**Sent:** 28/01/2020 4:13:21 PM  
**Subject:** Re: 41-43 Beach Road Collaroy NSW 2097 DA 2019/1522 WRITTEN SUBMISSION:  
LETTER OF OBJECTION Submission: Dorsen  
**Attachments:** 280120 35 Beach Road WS.docx;

**Re: 41-43 Beach Road Collaroy NSW 2097**

**DA 2019/1522**

**WRITTEN SUBMISSION: LETTER OF OBJECTION**

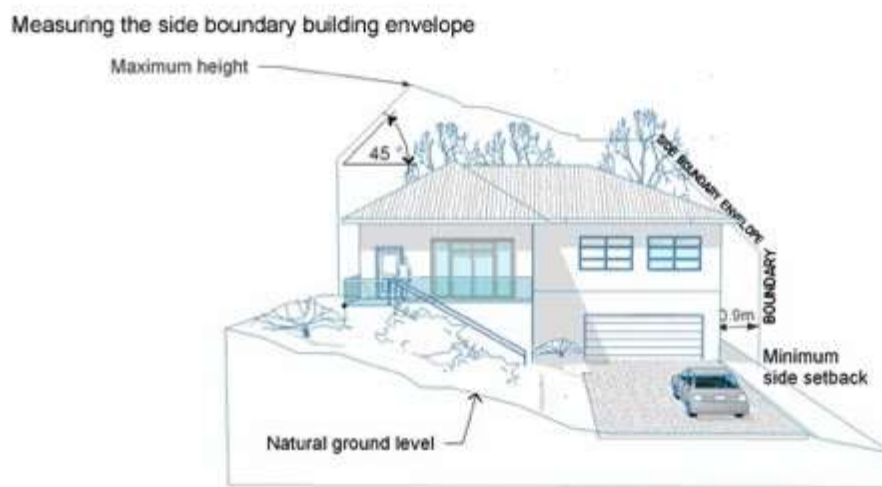
The development does become visually dominant by virtue of its height and bulk. As mentioned earlier a height and bulk of a development that rises to RL 19 from RL 4 at the south-east corner, in total defiance of this control, will present a massively visually dominant outcome, purely by virtue of its height and bulk.

The development does not ensure adequate light, solar access and privacy by providing spatial separation between buildings. Devastating outcomes of solar

access and poor privacy is obvious to any observer of the overshadowing drawings and other drawings.

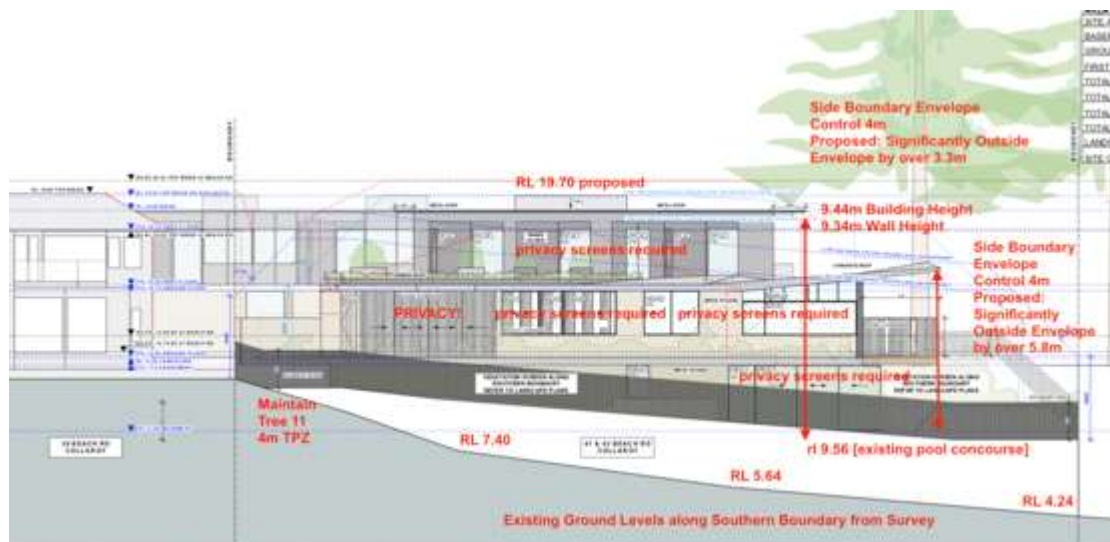
The top of the roof structure over the first floor at the south east corner is not shown with any level or scaled dimension to the boundary. Scaling from the Plan and South Elevation drawing gives 6.7m setback to the southern boundary, with a level at RL 19.0m.

The natural ground level at this location from the survey at the boundary is a mid point between RL 4.24 and RL 5.64, giving a level at RL 5.0. Allowing for a 4m control, plus a 6.7 setback, on top of the boundary level at RL 5.0, would result in a maximum side boundary control height of RL 15.7. The non-compliance would therefore be **3.3m**.

This is contrary to DCP controls.

To be compliant at the RL 5.0 boundary survey mark, the proposed roof at RL 19.0m, would need a side setback of **10.0m** [19.0 - 5.0 - 4.0]. The proposed

side setback is only **6.7m**, and Council can easily assess the substantial non-compliance. This is contrary to DCP controls.

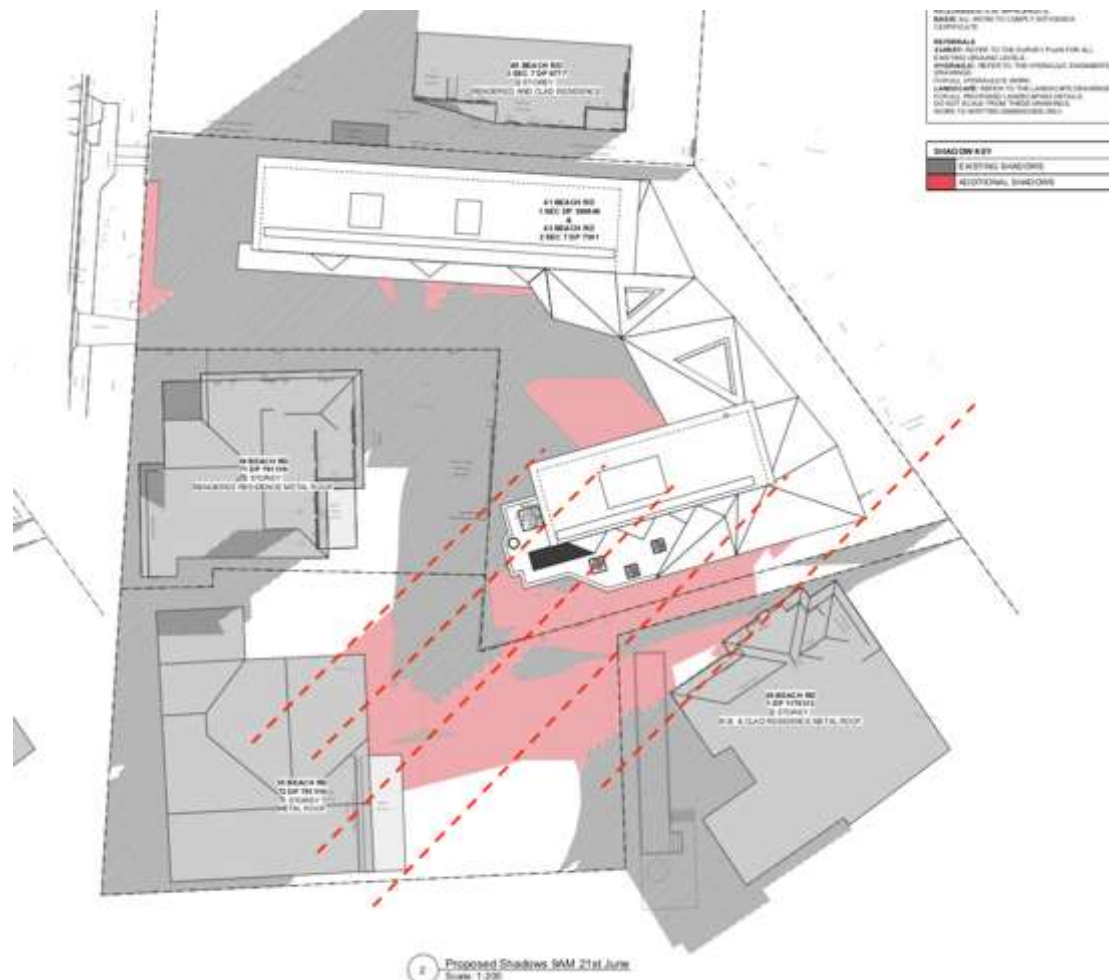
The east facing rooms to my house rely upon the winter morning sun from 9am to Noon. It is clear that our windows will lose sun from 9am Winter.

The non-compliant building envelope will cause unreasonable solar loss to neighbours.

The survey is incomplete into 35 Beach to fully describe the loss.

The 9am Winter shadows extend to my house alignment in plan and it would be expected that elevation loss to windows will occur to Decks, Living Room, Bedroom and Study, as well as an extensive loss to the lawn areas to 35 Beach Road from the non-compliant envelope.

**Photo 4:**

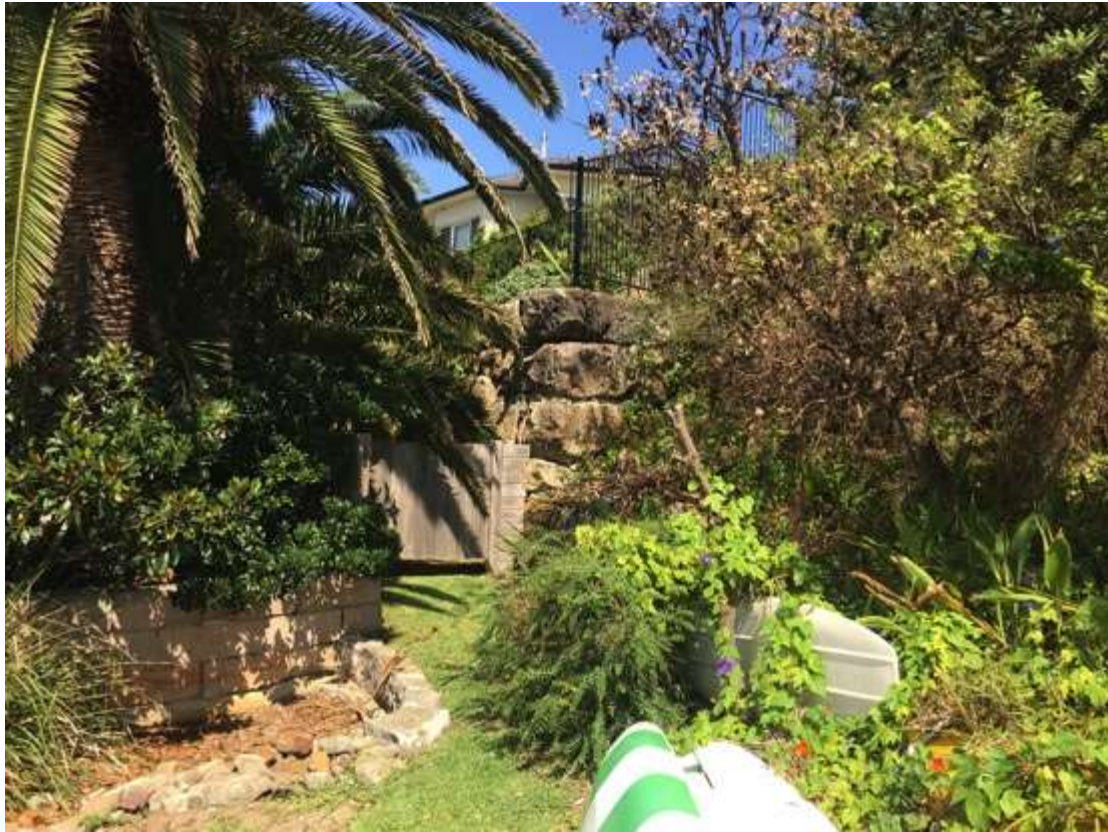
**View from Public Domain east of the subject site looking south west. Subject Site in foreground to the right. 35 Beach Road Residence in the centre of photograph. 29 Beach to the left.**

**Non-compliant development will take out solar access and view, and create privacy problems.**
